PRELIMINARY DRAINAGE REPORT

Storyrock Phase 1C

Drainage Review Memorandum

Re: Storyrock - Phase 1C
Case number: 5-PP-2016 #3

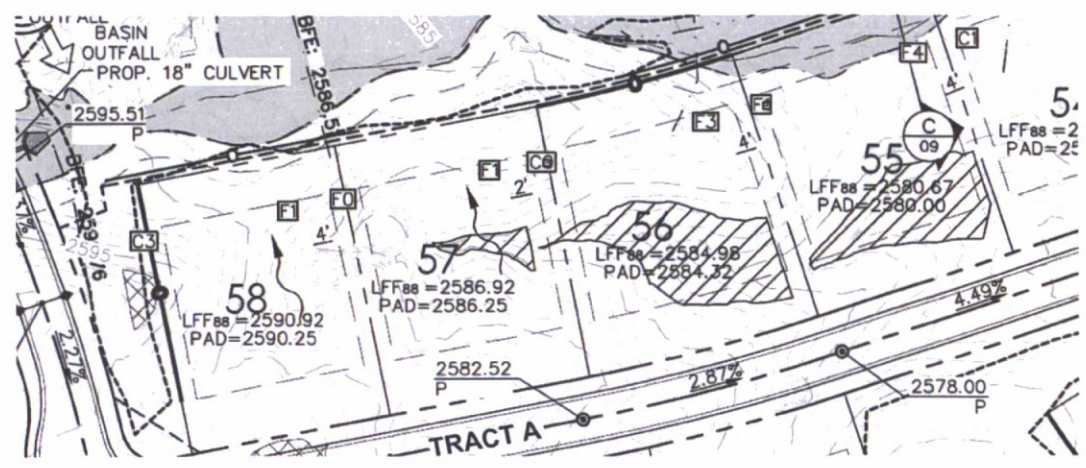
a. **COS 1st Review:** Existing contours should be labeled much more frequently so that the elevation of any existing contour within the development can easily be determined. At present, the bulk of the lots do not include any existing contour elevations within or near the lot.

COS 2nd Review: Additional labels are required. Please see grading and drainage plan screen capture below:

KHA Response: Existing contours labeled more frequently and indicate existing contour elevations near or within all lots.

KHA 2nd Response: Existing contours have been extensively labeled throughout the preliminary plat with this submittal.

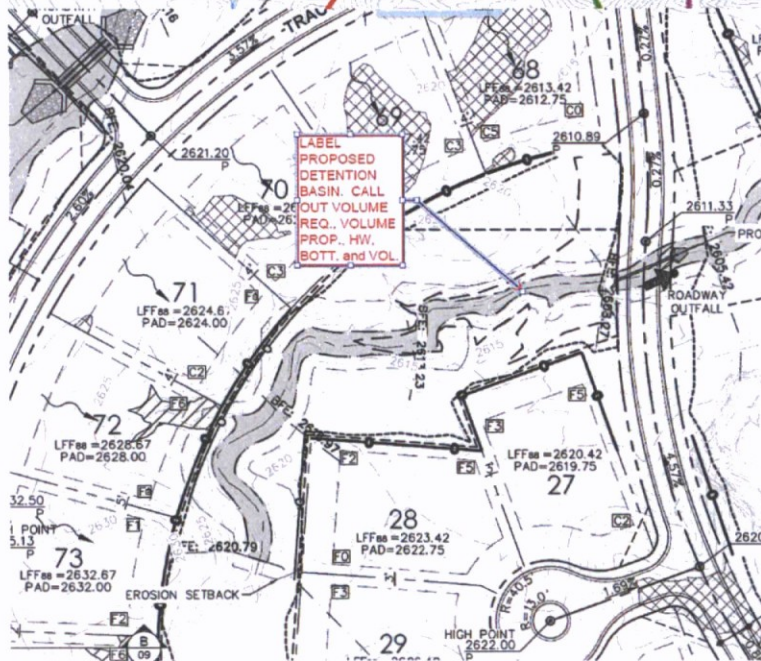
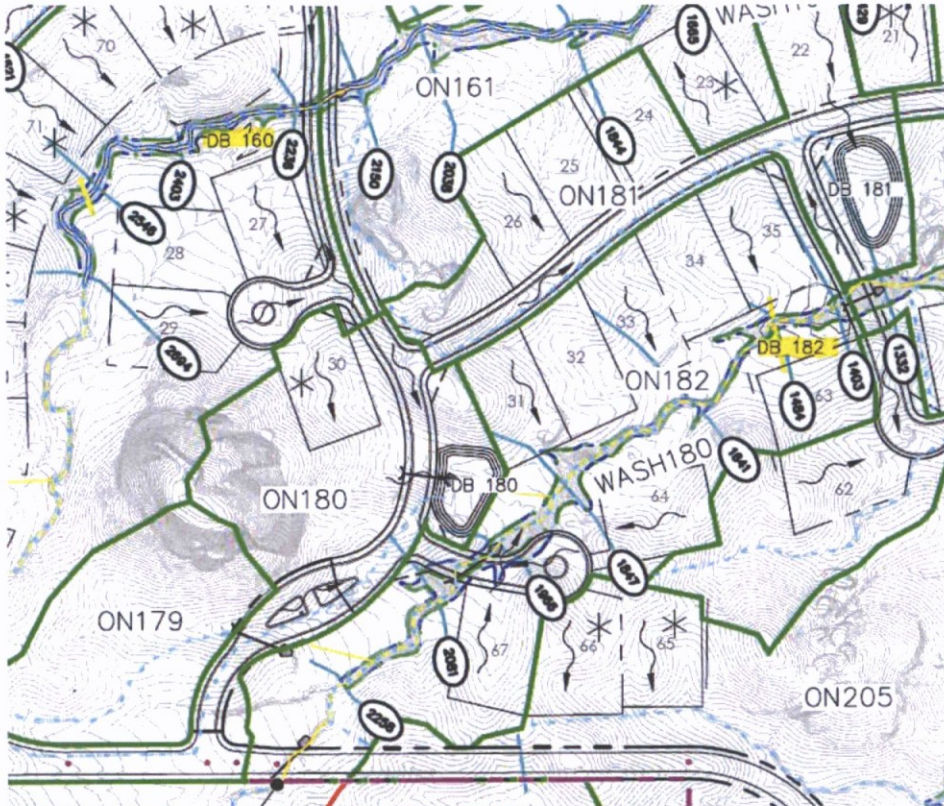
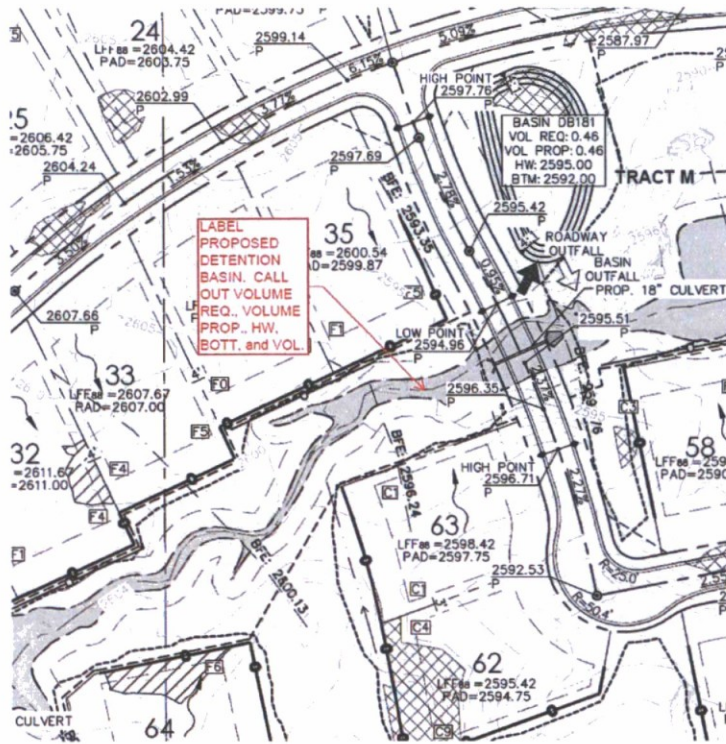
- COS 1st Review:** In-line Basin DB 160 is proposed to retain stormwater runoff with depth of 6 feet. Within a stormwater storage facility, safety concerns increase with an increase in potential water depth. A facility with a potential water depth of 2 to 3 feet (less than the head height of most users) is typically less dangerous than a facility with a potential water depth of 5 to 6 feet, or more. For reasons of safety, potential water depth in detention/retention facilities should be kept to a minimum. When possible, potential water depth of 3 feet or less is recommended for small stormwater storage basins immediately next to residential areas. In all facilities, regardless of depth, slopes in flood-prone areas should be kept as shallow as possible. This will allow users who find themselves caught in flooded areas (or users who deliberately enter flooded areas) to walk out and up to non-flooded zones. It is recommended that slopes in flood-prone areas be 4(H): 1(V) or flatter. Provide drain time analysis for DB 160 and discuss any physical barriers that will be implemented to prevent or discourage access to high depth storage facilities.

COS 2nd Review: Drainage report discussion on page 8 and basin summary table are not consistent, please review and revise basin label DB180 in discussion to DB182. Depict proposed in-line storage basin inundation limits and add basin callouts to preliminary grading and drainage sheets. Depict above discussed access barrier. Please address culvert sedimentation.

KHA Response: DB 160 is an in-line detention basin and roadway culvert crossing within the community. As with any culvert crossing located along an existing wash roadway crossing, peak flows will result in depths upstream greater than 3', as allowed. The headwall for DB 160 culvert inlet will include safety barriers to deter the community from access in this location, similar to many culvert crossings throughout the development. Drain time calculations have been added to the report to clearly show the minimal timeframe in which the basin will pond in this area.

KHA 2nd Response: DB180 has been revised to read correctly as DB182. Inundation limits and basin callouts were also added to the preliminary grading and drainage sheets. The headwalls for DB 182 and 160 culvert inlets will include standard headwall safety rail, similar and most common with roadway culverts throughout the City. DB 182 and 160 will operate in a similar fashion to any incised wash crossing in Scottsdale ESLO in a majority of the storm events and only experience depths greater than 3 feet for a very minimal timeframe, as provided in the drainage report. The adjacent roadway network is a private tract and does not provide for any trails or sidewalks near the culvert crossing.

Sedimentation is minimized through these crossing by maintaining existing wash grades and velocities through the culvert. The HOA will be responsible for maintaining the culvert and upstream condition of the inlet to remove periodic sedimentation that may occur. As discussed with the City, a maintenance report could be provided by the HOA to the City twice a year or after a larger storm event documenting the condition of the culvert crossing for DB 182 and 160 and any sedimentation removal performed. A discussion has been added to the drainage report.

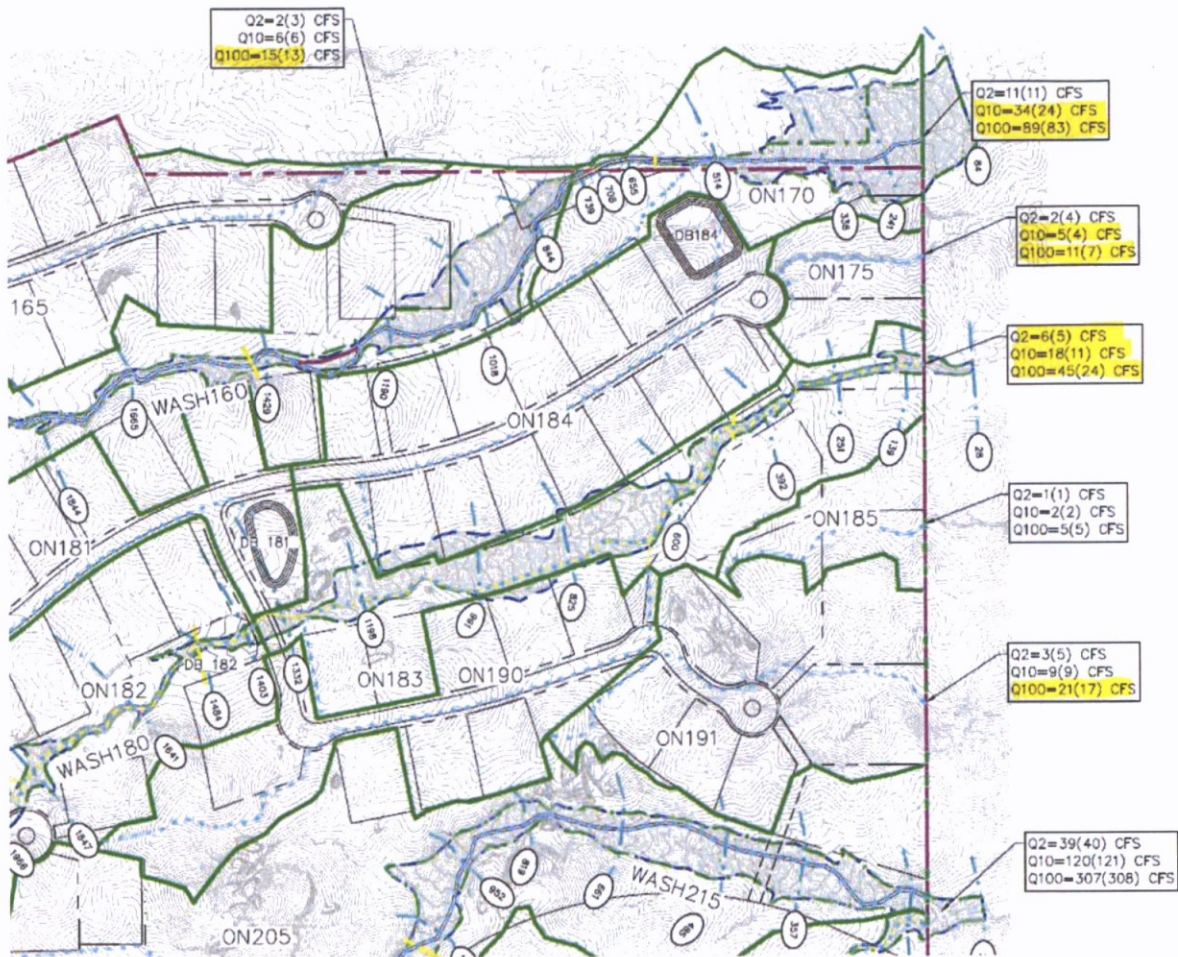
- COS 1st Review:** The preliminary drainage report will need to illustrate the project is meeting first flush requirements in general. The report should address whether proposed stormwater storage basins have been sized to meet the first flush requirement.

COS 2nd Review: Proposed alternative methods have to be approved by Stormwater Quality Coordinator (SQC). Any areas that are discharged directly to natural conveyance corridors have to be identified. Stormwater group is coordinating acceptable alternative methods with (SQC). Identify limits of disturbance required for implementation of alternative methods.

KHA Response: Detention basins proposed in the development meet first flush criteria. Some areas throughout the property propose to directly discharge into washes/channels that meander through the property. These areas have been identified in the drainage report and on the preliminary grading plan for alternative methods to stormwater pollution such as a stormceptor inlet structure. These areas are specifically proposed for alternative methods because the existing terrain and locations do not provide for adequate space or ability to grade a first flush basin to meet requirements. Furthermore, existing grades in these areas far exceed 5% slope and in some areas may require blasting. Stormceptor systems would be contained within the roadway tracts proposed and provide for an acceptable method to mitigate stormwater pollution exiting the property, however, additional alternatives may be proposed at final design and provided to staff for review and approval.

KHA 2nd Response: The alternative method proposed in various locations within the project are identified on the preliminary plat and discussed further in the drainage report. The areas shown are specifically proposed for alternative methods because the existing terrain and locations do not provide for adequate space or ability to grade a first flush basin.

As discussed with the City on April 12, a spillway and dissipation basin is an acceptable method by the Stormwater Quality Coordinator (SQC) to capture sedimentation and potential contaminants from street runoff in the areas constrained throughout the project. As requested, a detail has been provided with the Preliminary Plat and a discussion for the basin pool dimensions have been provided in the drainage report.

Figure 4. Proposed Drainage Condition.

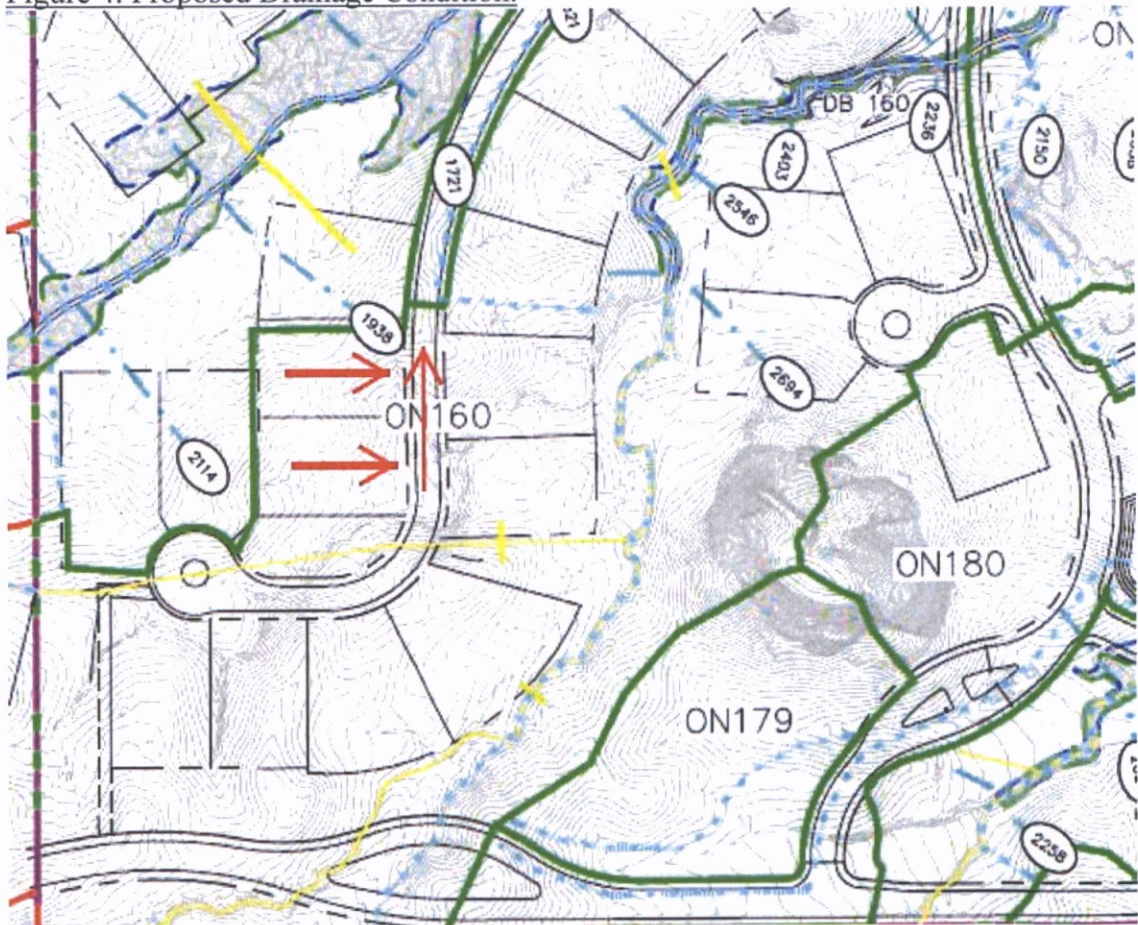
- 17. COS 1st Review:** Provide sufficient level of information to demonstrate how proposed on-site watersheds will be routed through stormwater detention facilities. Add flow direction arrows to Figure 4, Proposed Drainage Condition map to clearly demonstrate intended flow patterns. HEC-1 model proposes routing of most watersheds through detention facilities in effort to reduce post development peak flows. See sample watershed below, how are the two northerly lots draining to proposed detention basin? Preliminary Grading and Drainage plan (sheet 6 of 9) does not show flow interception and routing to the proposed detention basin, that is not consistent with HEC-1 analysis.
